HISTORIC AND DESIGN REVIEW COMMISSION

January 17, 2018

HDRC CASE NO: 2018-004
ADDRESS: 102 ALDER
LEGAL DESCRIPTION: NCB 1300 BLK 1 LOT 14
ZONING: R-5, H
CITY COUNCIL DIST.: 2
DISTRICT: Dignowity Hill Historic District
APPLICANT: Robert Richmond
OWNER: Meek Corp
TYPE OF WORK: Construction of a rear addition, porch modifications, window replacement, install fence
APPLICATION RECEIVED: December 21, 2017
60-DAY REVIEW: February 20, 2018
REQUEST:

LEFT (SOUTH) ELEVATION

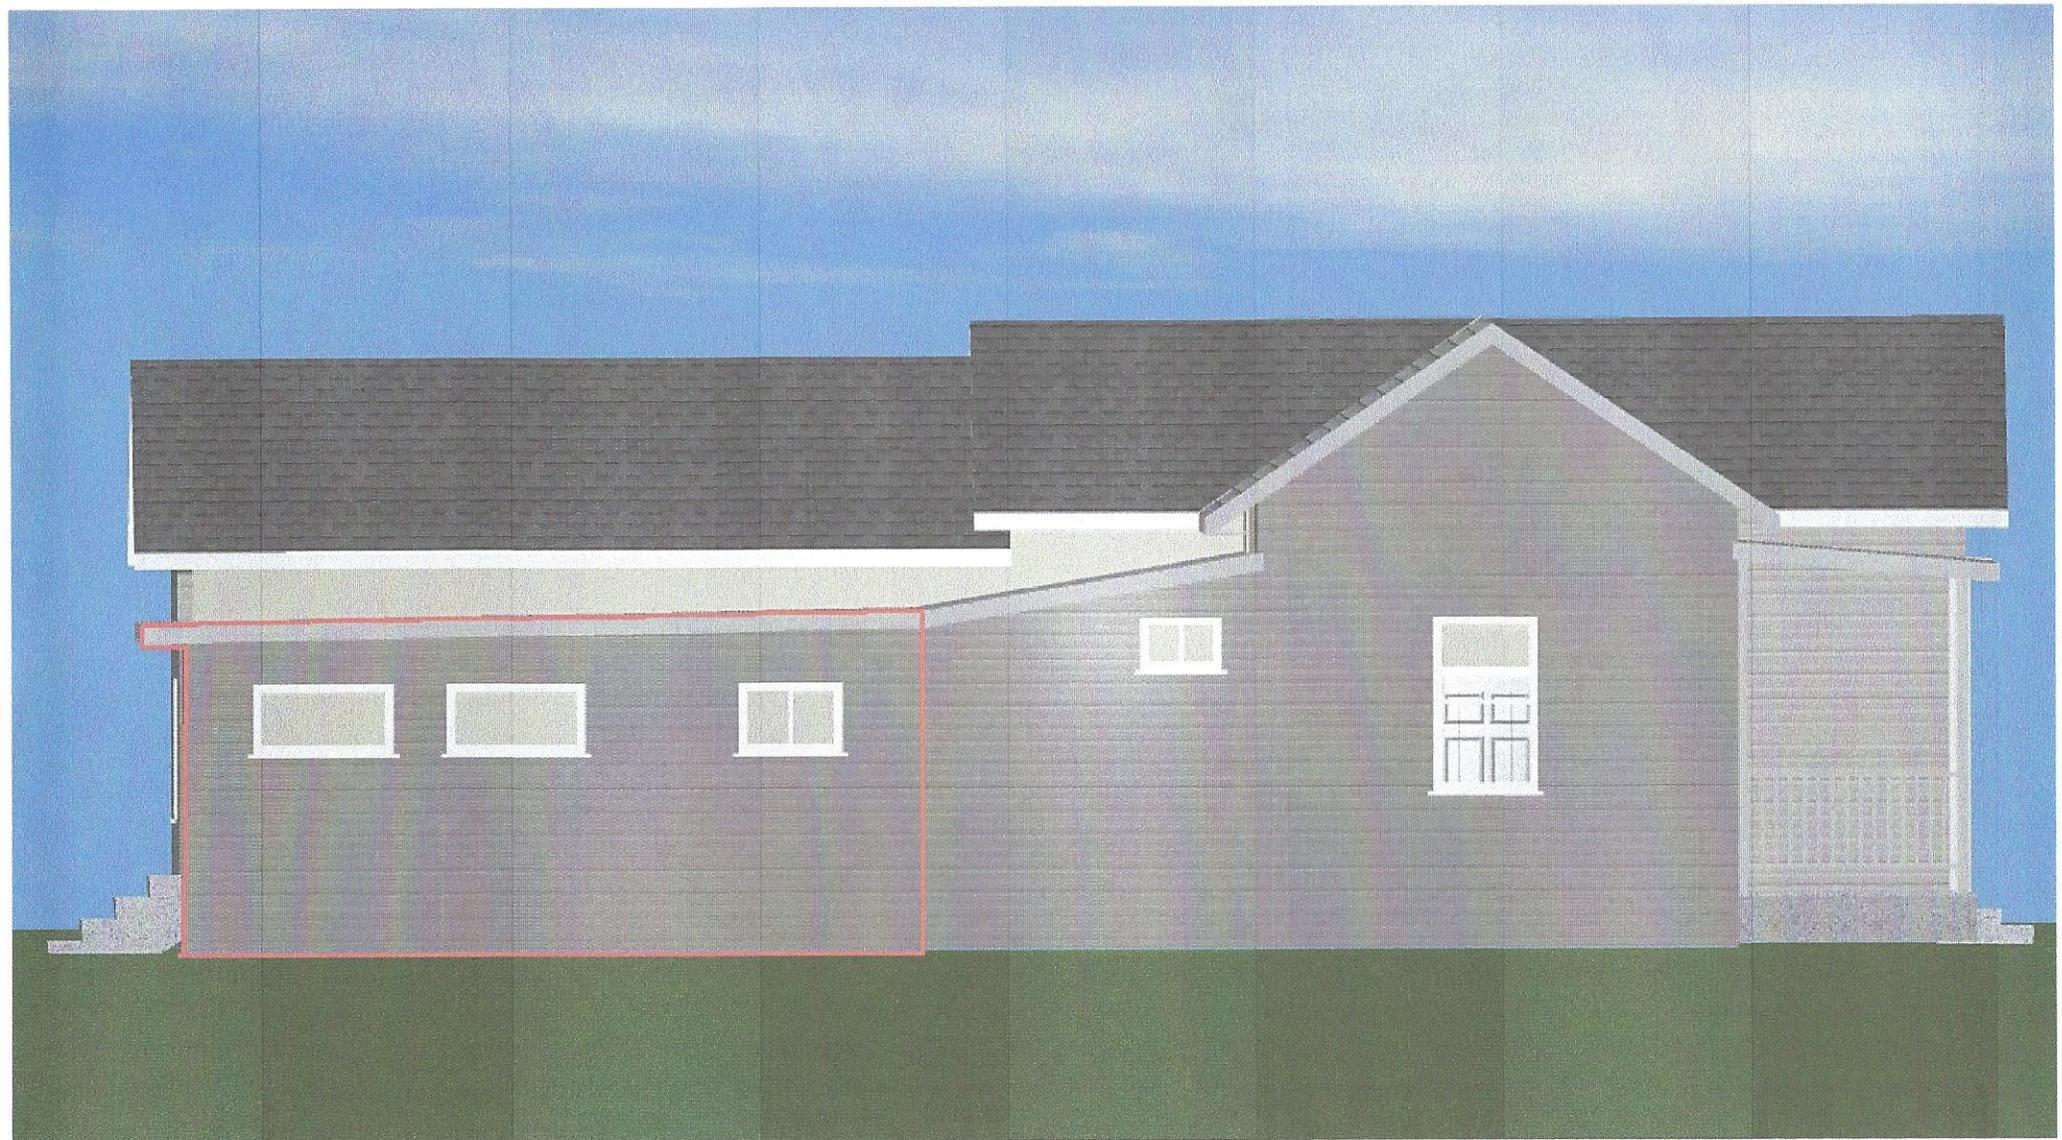
- b. ADDITION – The applicant has proposed to construct a rear addition featuring approximately 380 square feet. The addition features a flat standing seam metal roof extending from the existing shed roof. The addition also features three (3) windows on the side elevation and double doors leading to wood steps on the rear elevation. The addition will feature stucco skirting and wood siding to match the existing historic structure. Per the Guidelines for Additions, staff finds the massing, location, roof form, and materials of the addition generally appropriate. Per the Guidelines for Additions 3.1.A.iv, a setback and/or small change in detail should be included to provide a clear visual distinction between the old and new forms. The applicant is responsible for incorporating this detail into the design of the rear addition.

- a. WINDOWS – The applicant has proposed to install one (1) sliding wood window and two (2) awning wood windows on the side elevation of the proposed addition. Staff finds that all window opening should relate to those of the primary historic structure in profile, as noted in the Guidelines for Additions 4.A.i.

1. Staff recommends approval to construct and addition based on findings b and c with the following stipulations:
 - i. The addition includes a vertical trim piece to provide a visual distinction between old and new forms.

- ii. The addition feature window dimensions and configurations that are found on the historic structure.
 - iii. Updated construction documents are submitted to staff for review and approval prior to the issuance of a Certificate of Appropriateness.
